**Replat—Mayfair 2nd Addition, Replat 7—One  
Mayfair Place LLC**

RECOMMENDATION REPORT

CASE NUMBER: 2016-SUB-09

RE: Preliminary and Final Plat – Initial Review  
Mayfair 2<sup>nd</sup> Addition Replat Seven

# MAYFAIR 2ND ADDITION REPLAT SEVEN

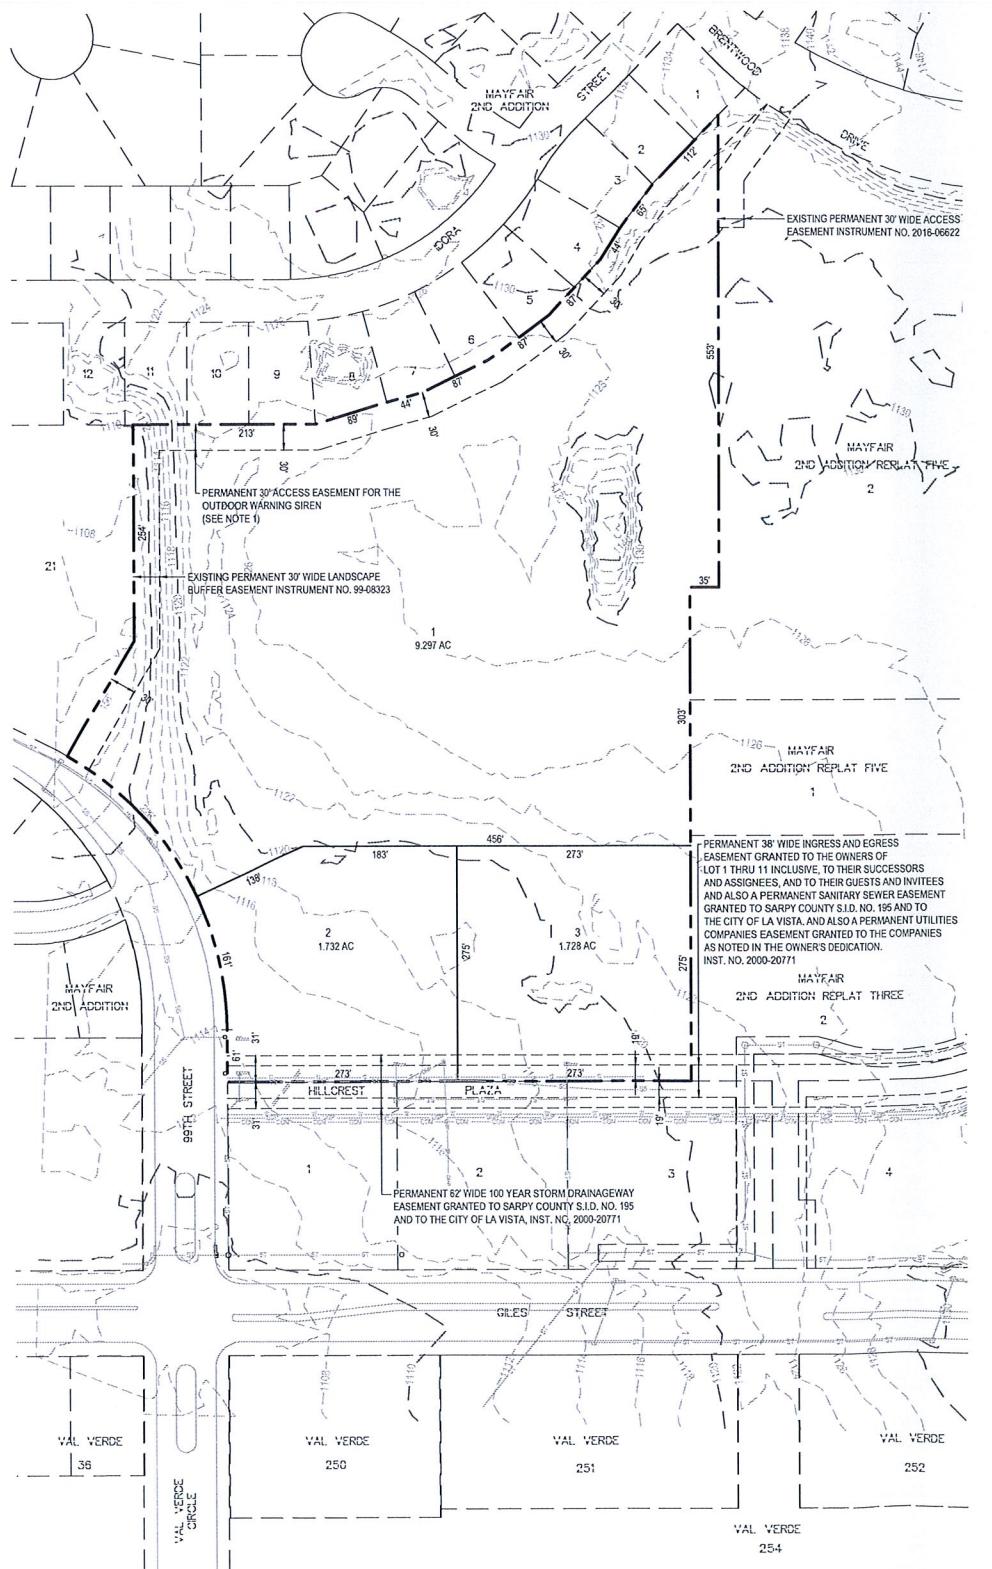
1. The preliminary plat needs to have a vicinity map added to it.
2. The existing storm and sanitary sewers in 99<sup>th</sup> Street need to be shown.
3. Note 2 on the preliminary plat needs to include wording that grading and erosion control requirements will be handled by each individual lot owner.

1. ALL EASEMENTS THAT ARE NOT LABELED WITH A BOOK AND PAGE NUMBER WILL BE RECORDED BY SEPARATE DOCUMENT.
2. LOTS 1, 2, AND 3 SHALL EACH BE RESPONSIBLE FOR THE DESIGN, CONSTRUCTION, GRADING, EROSION CONTROL REQUIREMENTS AND MAINTENANCE OF INDIVIDUAL LOT POST CONSTRUCTION STORMWATER MANAGEMENT FACILITIES.
